Doc or ECO #:	ECO-72061-001	Date:	7/19/19	Author:	AEG
	Rev. #:	A				
Engineering Change Order (ECO)	Engineering Approval:	aeg	Date:	07/19/19	Quality Approval	DO

P/N #:	72061	Effective Date:	May 31, 2019
Title:	Up armor of termination block whip

New strengthened term block assembly prior to installation.

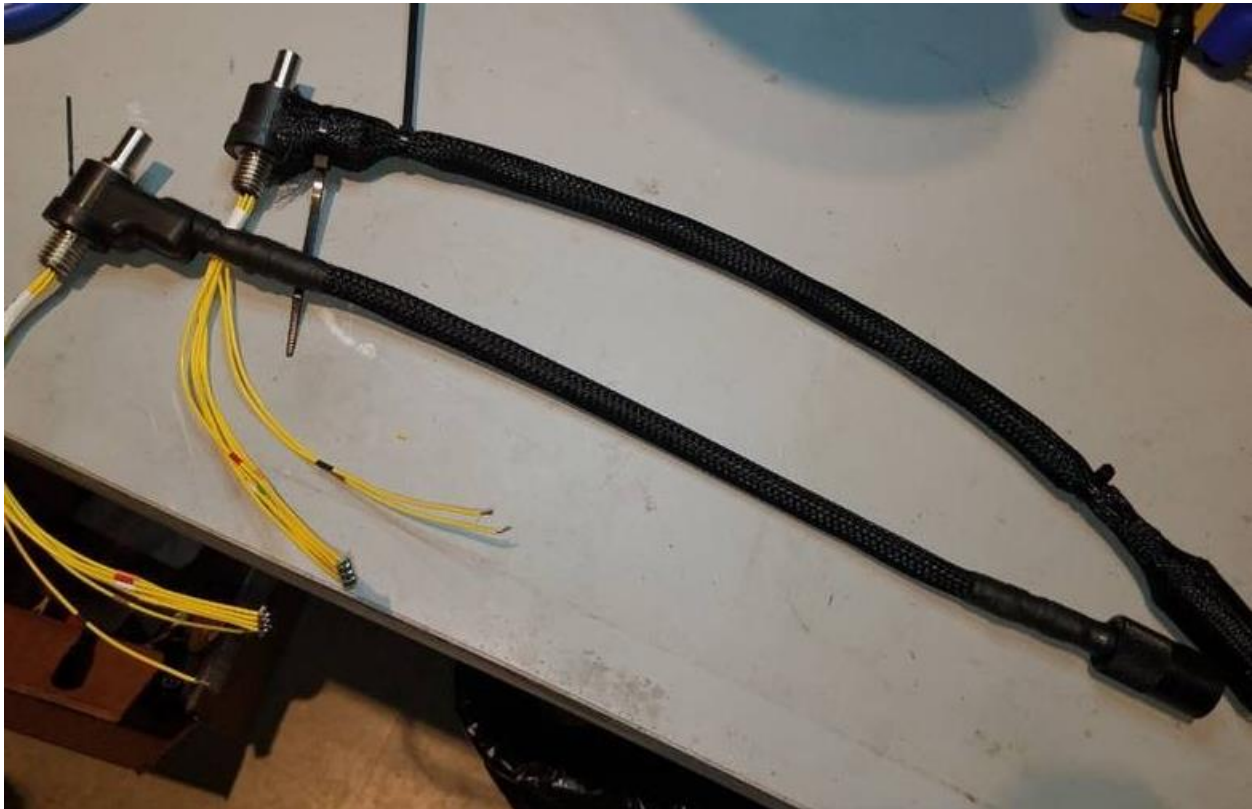
However, it was still deemed prudent to move to an enhanced strength mechanism for the termination block whip.

TB-001M is to be replaced in with a new assembly [72061] which includes an external nylon strain relief braid. This braid can be added to TB-001M either before or after installation on the ROV.

It is possible to perform this upgrade in the field.
